MEMORANDUM

SUBJECT: Addendum to the Burton and Highlands Parks Project Final Environmental Impact Report (EIR), State Clearinghouse #201752066

FIGURE 2

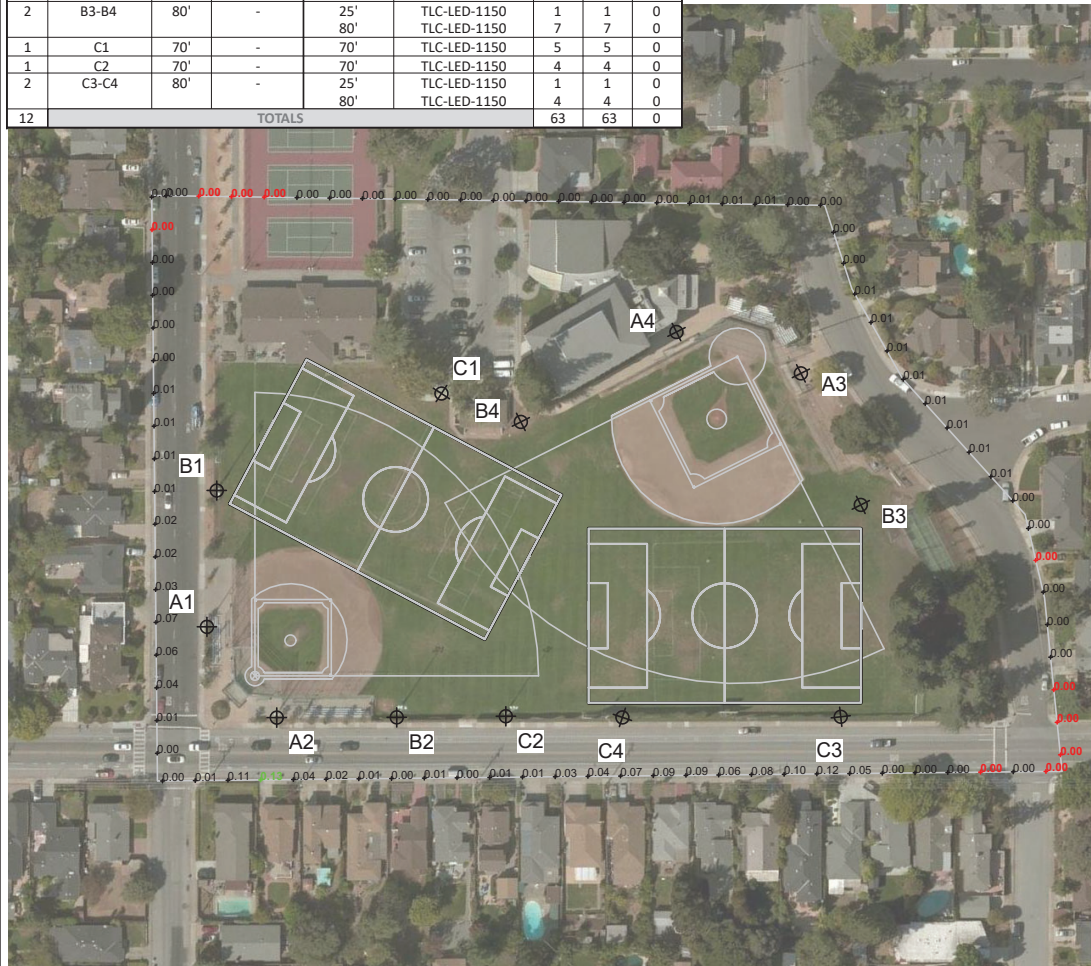
Burton Park. The 2018 Project included replacement lighting at Madsen Field that would utilize the existing light poles and replace the existing metal halide light fixtures with new LED light fixtures. The five existing poles at Madsen Field would hold a total of 30 new LED light fixtures and five new uplight fixtures, for a total of 35 fixtures. New lighting at Flanagan Field included six new light poles that would be 70 to 80 feet in height and would hold a total of 43 new LED light fixtures. As shown in Figures 1 through 3, the lighting included in the 2018 Project would have a maximum spillover (i.e., the amount of light at the property line) of 0.09 horizontal footcandles³ and 0.13 vertical footcandles, and 2,588 candelas.⁴ All three maximums would occur along Brittan Avenue. The average spillover across the project site would be 0.010 horizontal footcandles, 0.017 vertical footcandles, and 513 candelas.

FIGURE 10

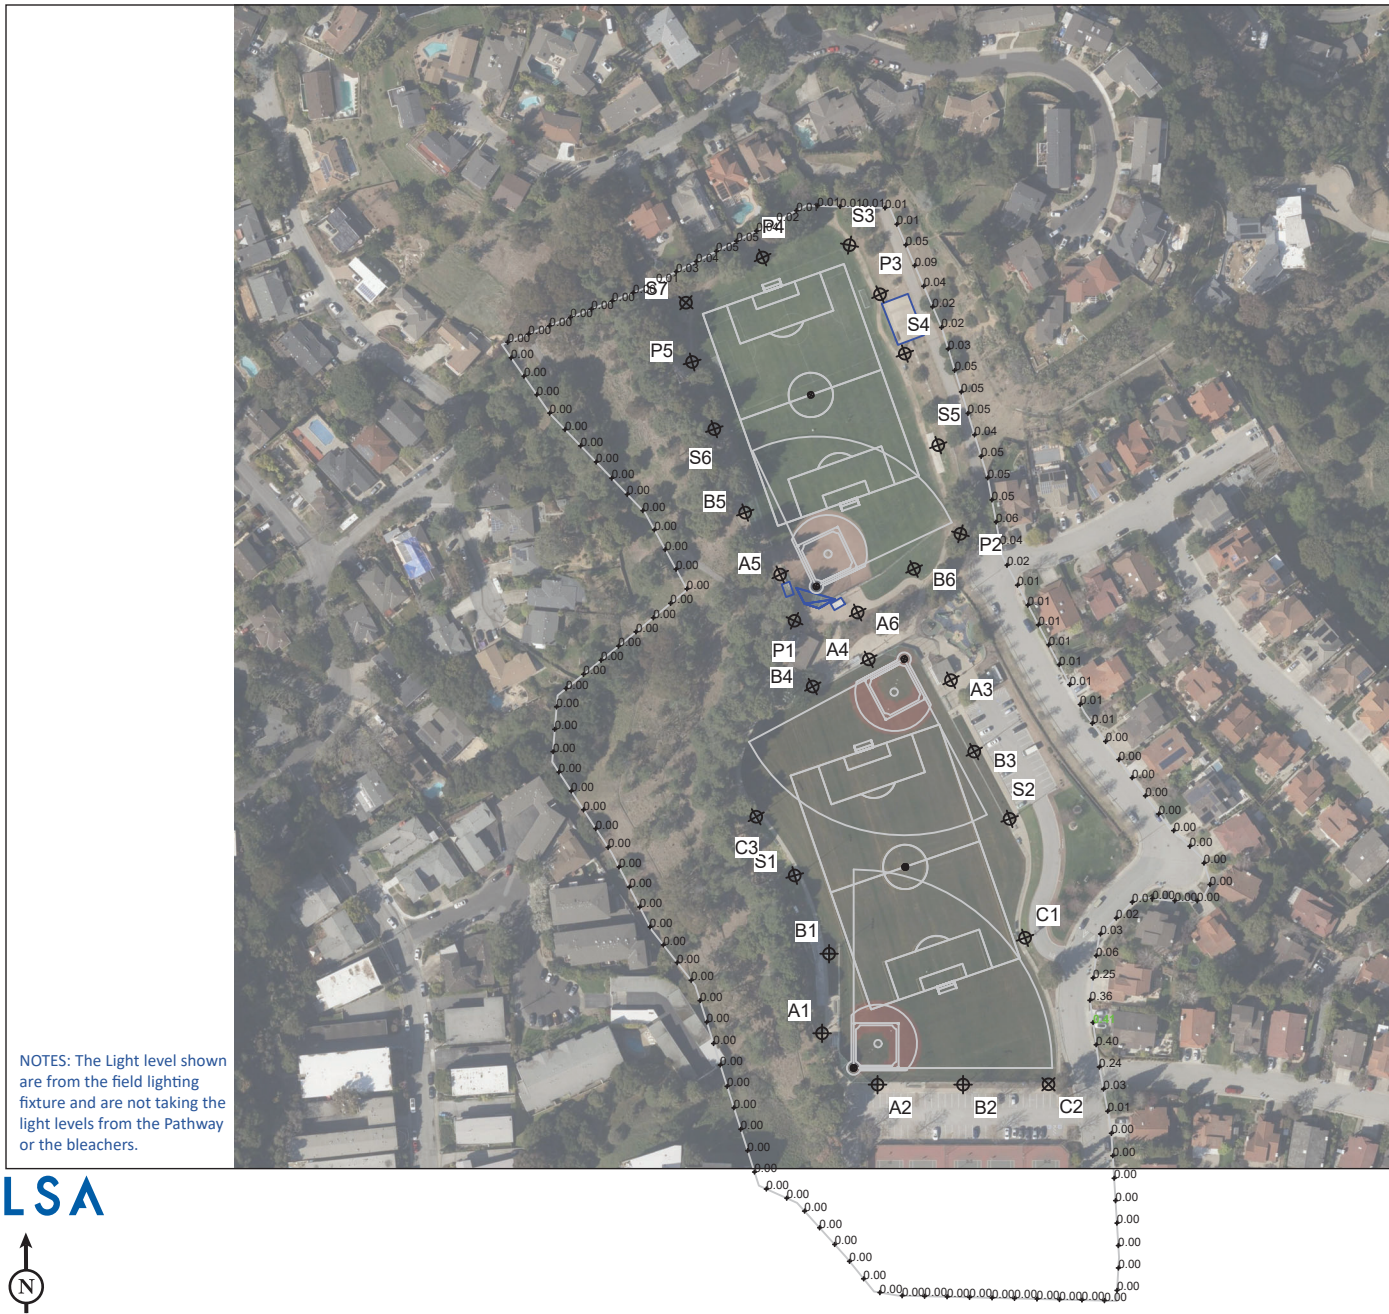
Highlands Park. The location of the fixtures and poles on the west side of the fields would be slightly adjusted. Five additional poles with only security pathway lighting would be installed along the existing path around the fields. Additionally, new lighting would be installed around the batting cages. No other modifications to the lighting system would be made. As shown in Figures 10 through 12, the minor modifications would result in a maximum spillover of 0.41 horizontal footcandles, 0.77 vertical footcandles, and 9,520 candelas, all of which would occur at the southeast corner of the site. The average spillover across the site would be 0.02 horizontal footcandles, 0.06 vertical footcandles, and 1,034 candelas. All lighting levels, including both average and maximum levels, would be slightly higher than the 2018 Project.
